# ORDER: AUTHORIZE PROPOSED CHANGE ORDER #16 FOR THE NEW LAFAYETTE COUNTY SHERIFF'S DEPARTMENT FOR CHANGES TO THE FIRE ALARM SYSTEM AND EXIT SIGNS

RE: A New Sheriff's Department Building
and Improvements at the Detention
Center— Phase 2 (Rebid 2)
Lafayette County Board of Supervisors
PCO #16 – Lighting and Fire Alarm System Changes

Change Proposal 016

# **Change Order #8**

LIGHTING PLAN - BASEMENT B1

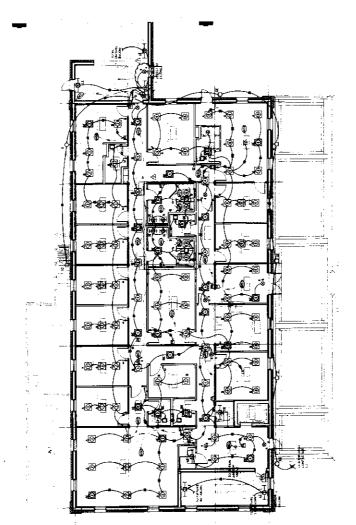
- On E1.0— Moved redundant exit sign from <u>Lobby B03</u> to Door B21B (exit door & second means of egress from basement B1) and changed arrow direction on exit sign in <u>Corridor B21B</u> to point toward Door B21B.

LIGHTING PLAN - GROUND FLOOR

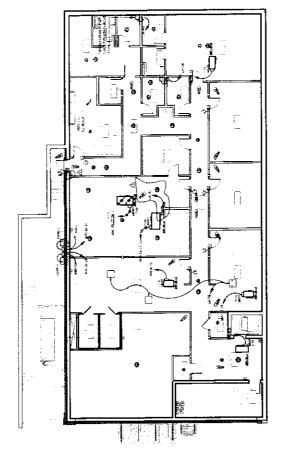
- 2. On E1.1—Added new exit sign at Door 130C (exit door & second means of egress from second floor).
- 3. On E1.2—Added new exit sign at Door 220 at top landing of <u>Stair 220</u> with arrow pointing N, to direct building occupants down stair leading to <u>Stair 130</u> and Door 130C (exit door & second means of egress from second floor).

MECHANICAL/AUXILIARY PLAN - BASEMENT 82 (10) Scale 1/8" = 1°0"

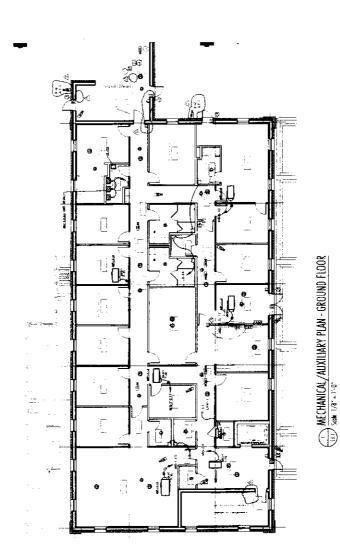
- 4. On E3.0— Moved FACP from E. wall to N. end of wall separating entry/locker area from kitchen area in E911 Operations Center B18 to resolve conflict with furniture at a dispatch position; Added pull station (from Door 101-see #5 below) to Door B201B (exit access door) in Lobby B203; Moved pull station from hinge side to latch side of Door B21B.
